Mark	Date	by	Chk	Rvd	Revision
PL2	30/10/20	GG	RL	PK	ISSUED FOR PLANNING ALTERATIONS

Drawing Status: PLANNING ALTERATIONS

Job Title: INDUSTRIAL DEVELOPMENT AT LAY LANE, GREENOGUE, RATHCOOLE, Co. DUBLIN

Drawing Title: BLOCK A - ENLARGED ANCILLARY OFFICES/STAFF FACILITIES GROUND & FIRST FLOOR PLAN

ENLARGED GROUND FLOOR PLAN FOR CLARITY OF ANCILLARY OFFICE/ STAFF/ WC & STORAGE FACILITIES LAYOUT
SCALE 1:100

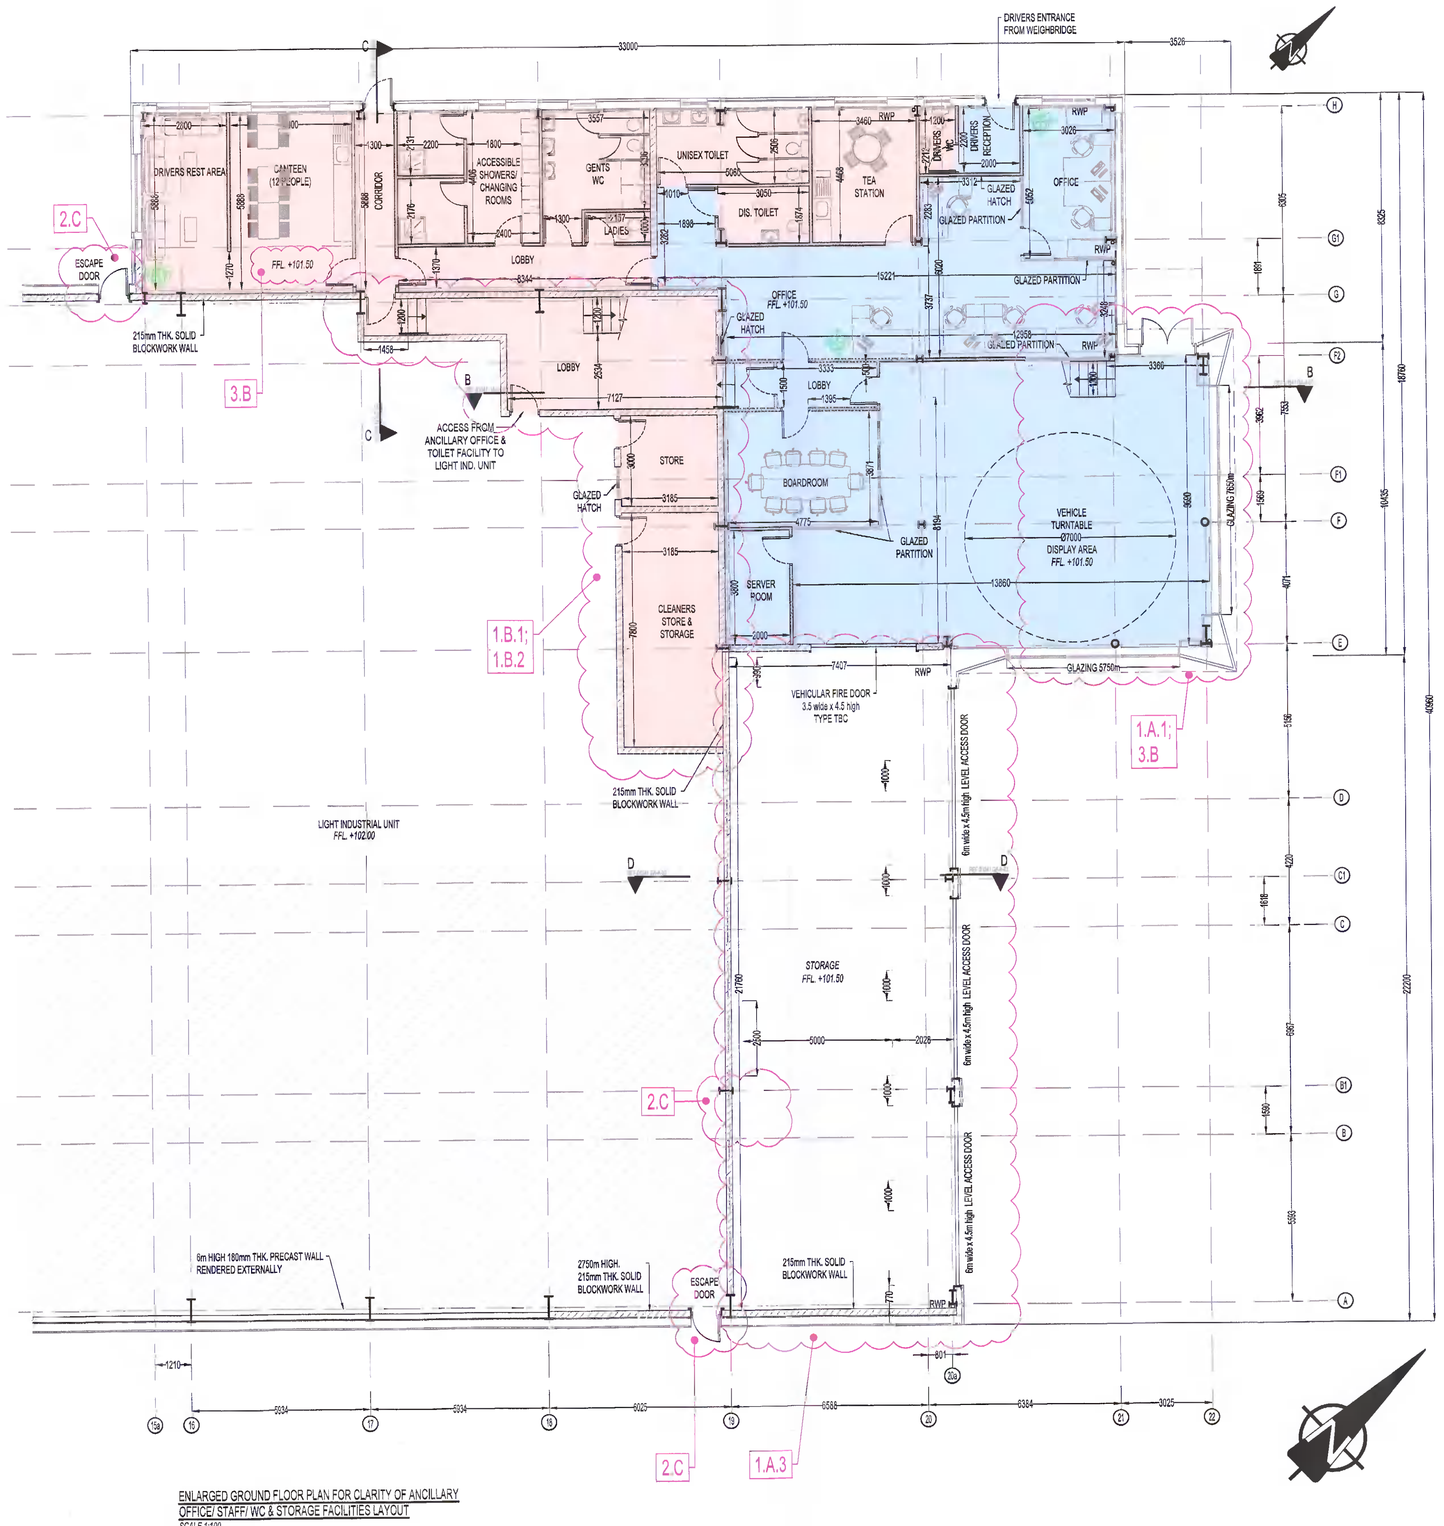
1. RECONFIGURATION OF THE FLOOR PLAN AREAS AS FOLLOWS:
A Provision of 535m² additional floor area due to introduction of areas as follows:
A.1 Extended display area at ground floor of ancillary Office, addition of 46m² floor area;
A.2 Extended open plan office at first floor of ancillary office, addition of 20m² floor area.
A.3 Single storey ancillary storage facility to the front north-east elevation, totalling 192m², overall height 7m.
A.4 Mezzanine area to the south eastern side of Light Industrial Unit, totalling 300m².
Alterations listed above result in total building area increase from 4391m² to 4926m² as shown at the revised table of gross internal floor areas & uses.
B Change of use of 64m² of Light Ind. Unit floor area to staff facities due to the introduction of:
B.1 Enclosed stairs from Light Industrial Unit to ancillary Office/Staff facilities (overall 15m²).
B.2 Single storey cleaners store and storage at ground floor to the north-eastern corner of Light Industrial Unit (overall 33m²).

C Change of use of 102m² of workshop charging area & staff facilities to workshop area & single storey office/staff facilities.
D Introduction of full height dwelling wall at Light Industrial Unit.
